Service Bulletin

101 East Seneca Bancroft, IA 50517	Bulletin #: 100715	Date: 10-07-15
Prepared by: Bob Mortenson	Phone # 515-885-2398	Page: 1

Inform Aluma dealers and owners that 5410T tilt trailer may have missing weld that may contribute to a failure of the trailer’s tongue weldment.

Figure 4

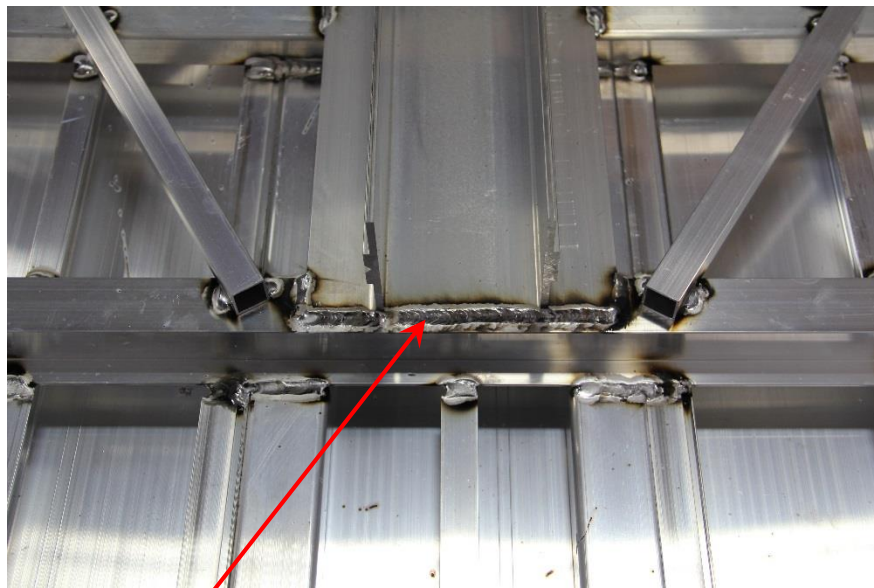
- 3.0 Figures 4 and 5 shows different orientation of tongue retainer. If welds are missing, then add .25” fillet welds as shown See Figure 4 and 5. **Note:** Ensure that wiring harness is not damaged during welding.

If weld is missing add .25" fillet welds as shown

Figure 5

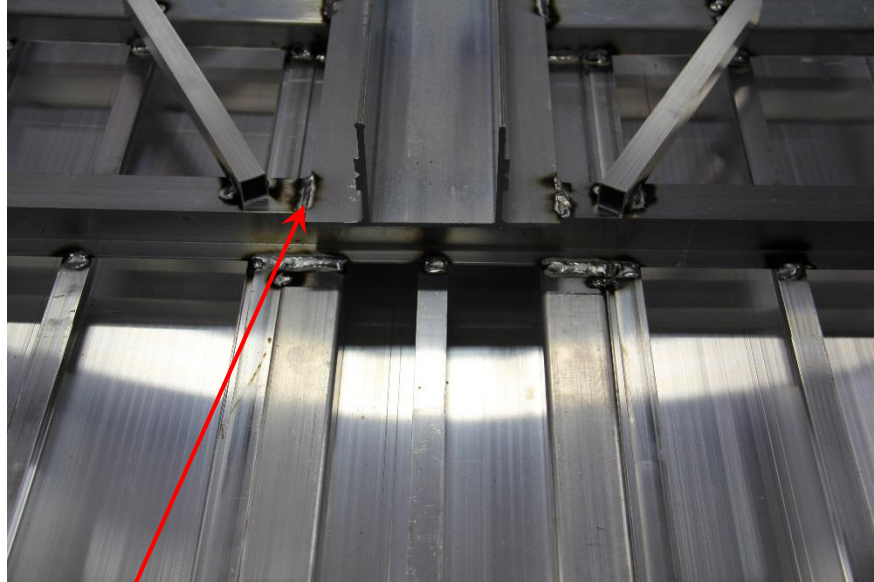
If weld is missing add .25" fillet welds as shown

Figure 6

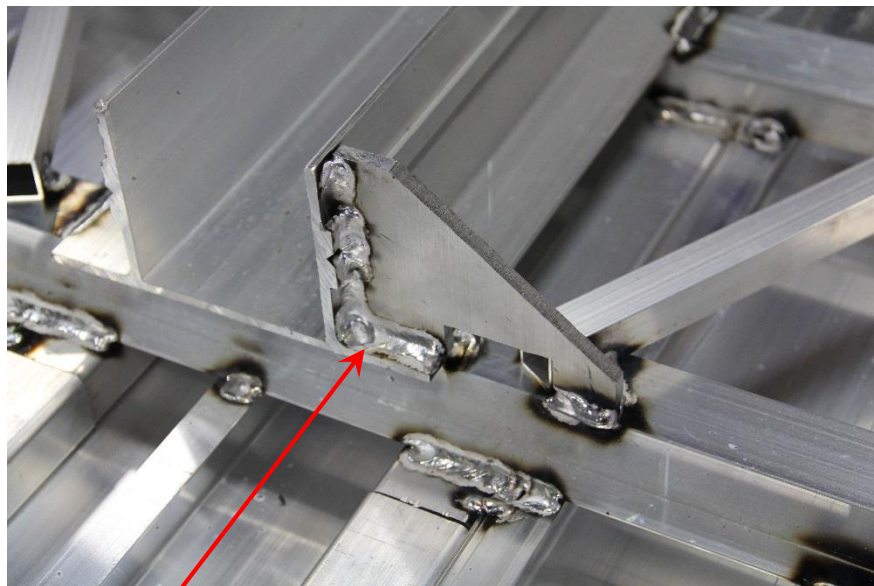
- 4.0 Add 2 gussets and .25” fillet weld as shown in Figure 6 and 7.
- 5.0 Verify work has been completed and all tools and hardware is secured. Raise trailer and remove jack stands.

Add 2 gussets and .25" fillet welds as shown.
One gusset on each side of tongue retainer.

Figure 7

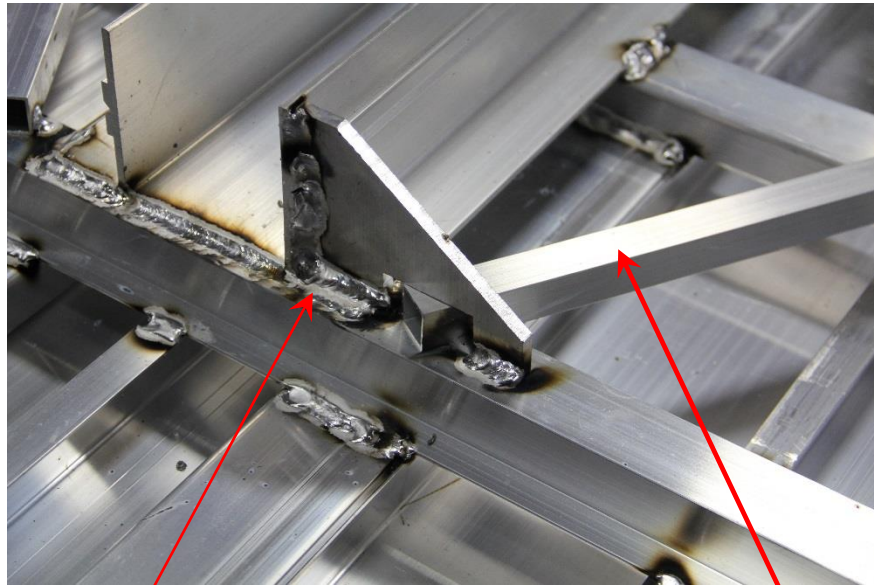
Add 2 gussets and .25" fillet welds as shown. One gusset on each side of tongue retainer.

Adjustment of wire tubes maybe necessary for proper gusset orientation.
